November 6, 1981

SUBJECT: Calvert Cliffs Nuclear Power Plant Units 1 and 2
Docket Nos. 50-317 and 50-318
Inservice Inspection and Pump and Valve Programs
Request for Relief from ASME Code
Section XI Requirements Determined to be Impractical

REVISED EXAMINATION VOLUME FOR CLASS 1 BOLTING WHEN SCANNED FROM THE CENTER-DRILLED HOLE

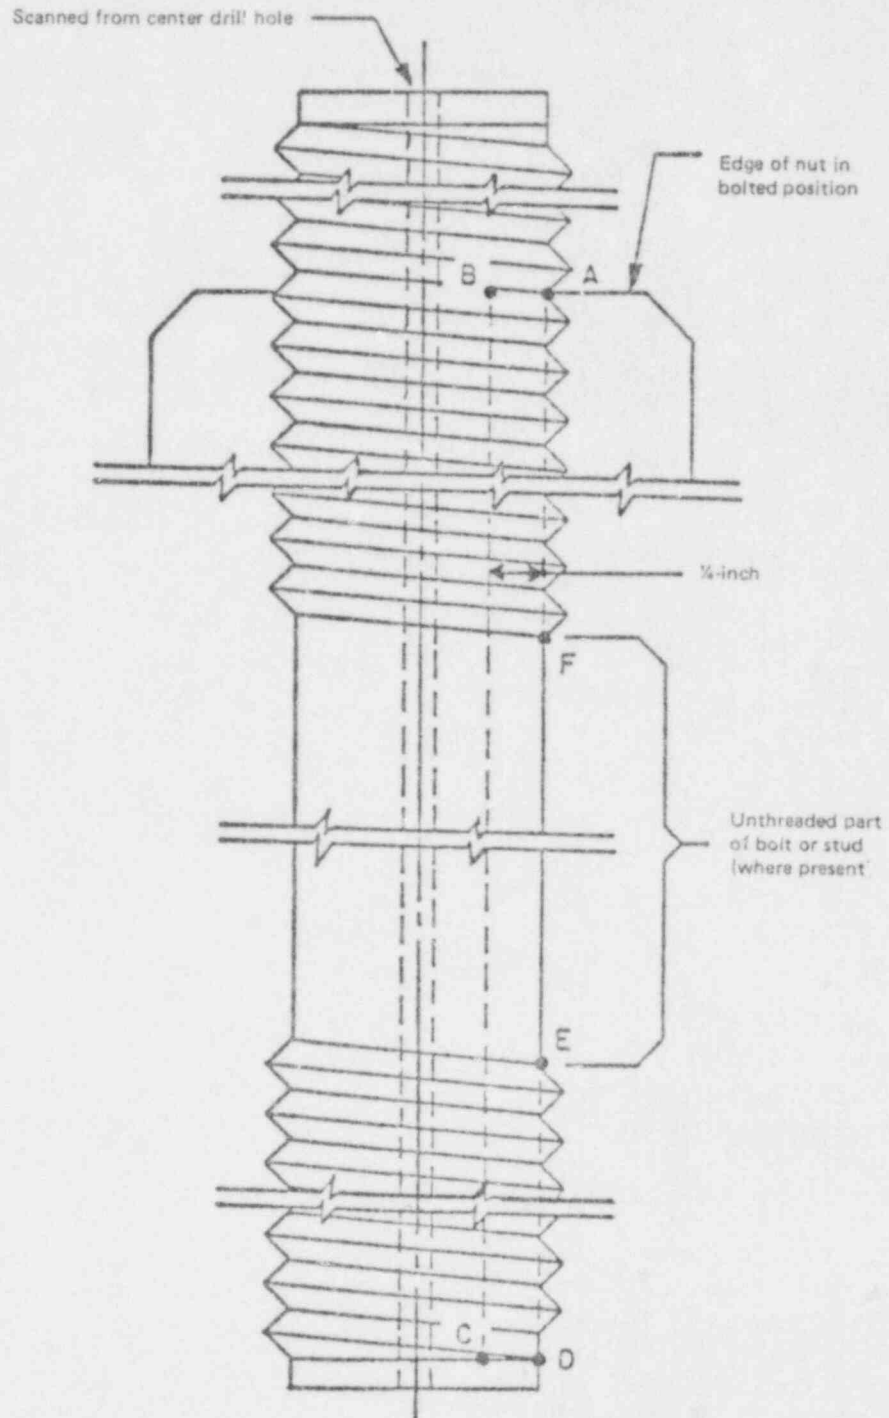
Inquiry: When ultrasonic examinations are conducted from the center-drilled hole of Class 1 bolts or studs to satisfy the examination requirements of Examination Category B-G-1, may the examination volume be limited to the cylindrical region defined by A-B-C-D-E-F-A in the attached sketch?

Reply: It is the opinion of the Committee that, when conducting ultrasonic examinations from the center-drilled hole of Class 1 bolts or studs to satisfy the examination requirements of Examination Category B-G-1, the examination volume may be limited to the cylindrical region defined by A-B-C-D-E-F-A in the sketch referenced by the Inquiry.
